HUGHES SERVICE INFORMATION NOTICE

NOTICE NO. N-153.1*

SUBJECT: INSPECTION AND REWORK OF LTS TAIL ROTOR HUB
PN 369A1725, 369A1725-5, and 369A1725-501

MODELS AFFECTED: Model 269C Helicopter Serial No. 0004 through 0716. All Model 269A, TH-55A, 269A-1 and 269B Helicopters equipped with LTS Tail Rotor Assembly, PN 269A6034 Series. The following Tail Rotor Hub Assemblies (separate or component of PN 269A6034 Tail Rotor Assembly) in Spares Inventory at date of this Notice:

Figure 1. Rework of tail rotor hub assembly

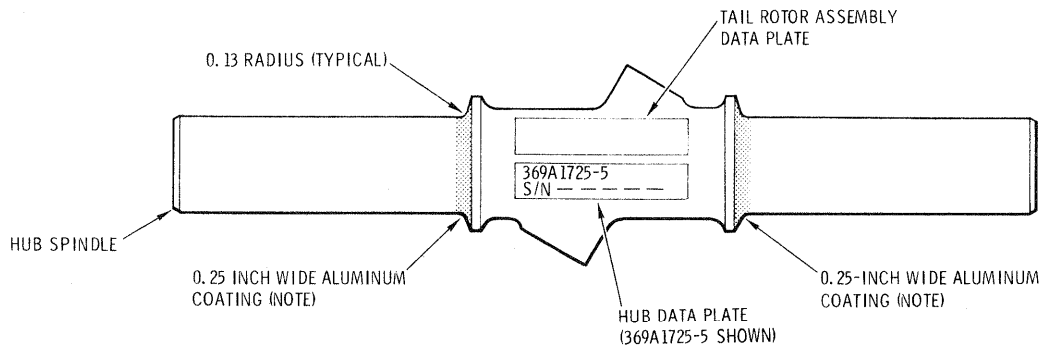
- a. As applicable, remove tail rotor assembly from helicopter and remove tail rotor blade assemblies, per Basic HMI. Disassemble hub and drive fork assembly, per Component Overhaul Manual (HMI Appendix C).
- b. Clean hub with trichloroethane.
- c. Using 10X glass, inspect hub for cracks, corrosion or other damage. Pay particular attention to area of 0.13 radii between the spindles and center portion of the hub. (See Figure 1.)

1. Shake contents of container thoroughly.
2. Brush a thin (0.002 to 0.005 inch) even coat onto cleaned surface of 0.13 radius areas on both sides of hub. (See Figure 1.) Limit width of aluminum coating to 0.25 inch to prevent contact with feathering bearings.
3. Allow a flash-off (drying) time of 8 to 10 minutes.
4. Bake hub for 1 hour at 375° to 425° F in oven or use heat lamps.
5. Air cool hub.

f. To denote rework of 369A1725-5 or 369A1725-501 hub, add letter "Z" following serial number on hub data plate; to denote rework of 369A1725 hub, add letter "Z" following part number on tail rotor assembly data plate. (See Figure 1.)

LIMIT WIDTH OF ALUMINUM COATING TO 0.25-INCH TO PREVENT CONTACT WITH FEATHERING BEARINGS.
